# NONRESIDENTIAL ~~ACM MANUAL~~ APPENDIX ~~NA6~~ (Formerly ~~NRACM NH~~)

## Appendix ~~NA6~~ - Alternate Default Fenestration Thermal Properties<sup>1</sup>

[Table NA6-1. U-Factors for Various Vertical Fenestration Products in Btu/h-ft<sup>2</sup>-°F<sup>vii</sup>](#)

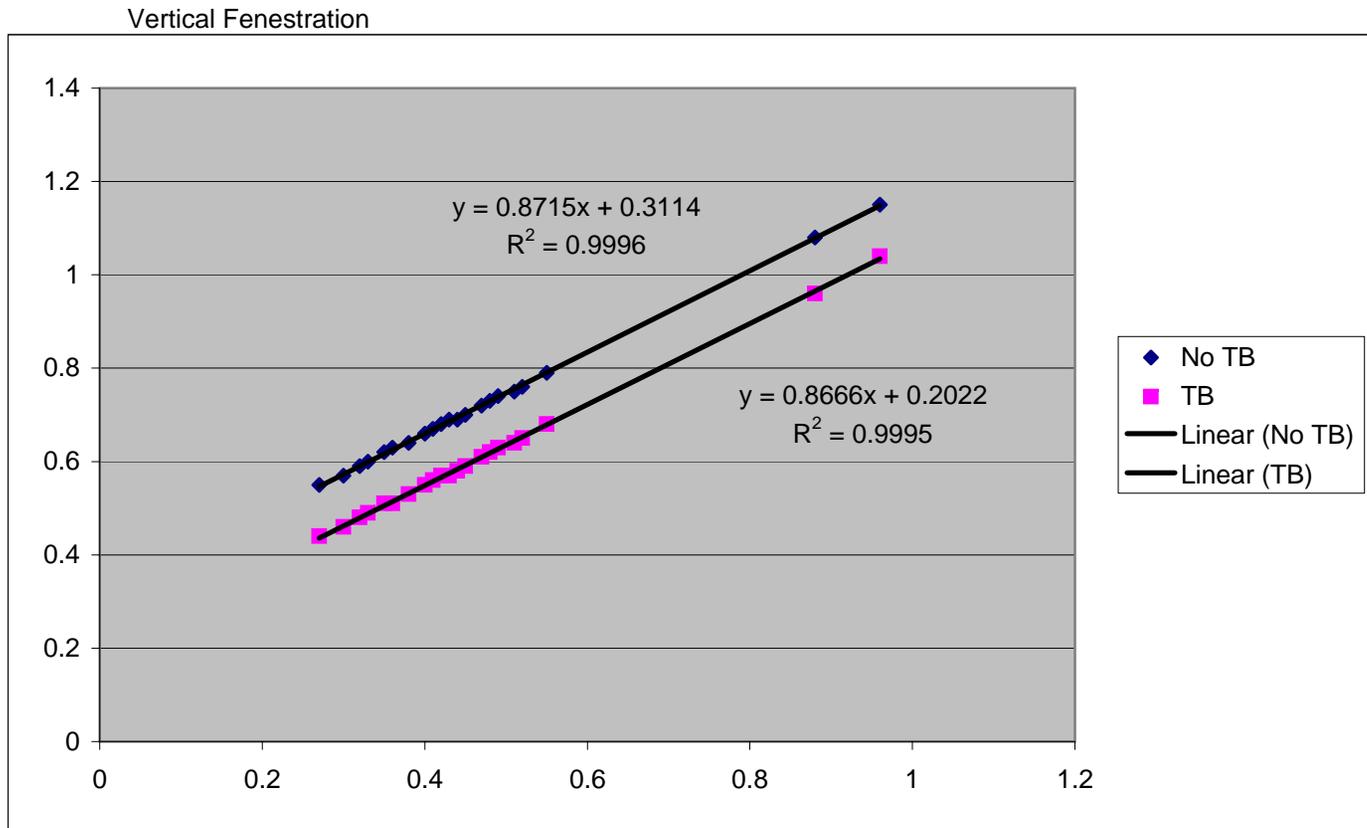
<sup>iv</sup> Former Table NI-1 has been revised and split into Table NA6-1 (Vertical Installation) and Table NA6-2 (Sloped Installation). See full comments with tables.

<sup>vii</sup> The revisions to Tables NA6-1 and NA6-2 were made in order to make Table NI-1 less confusing. The table data source is the 2005 ASHRAE Handbook of Fundamentals (Table 4).
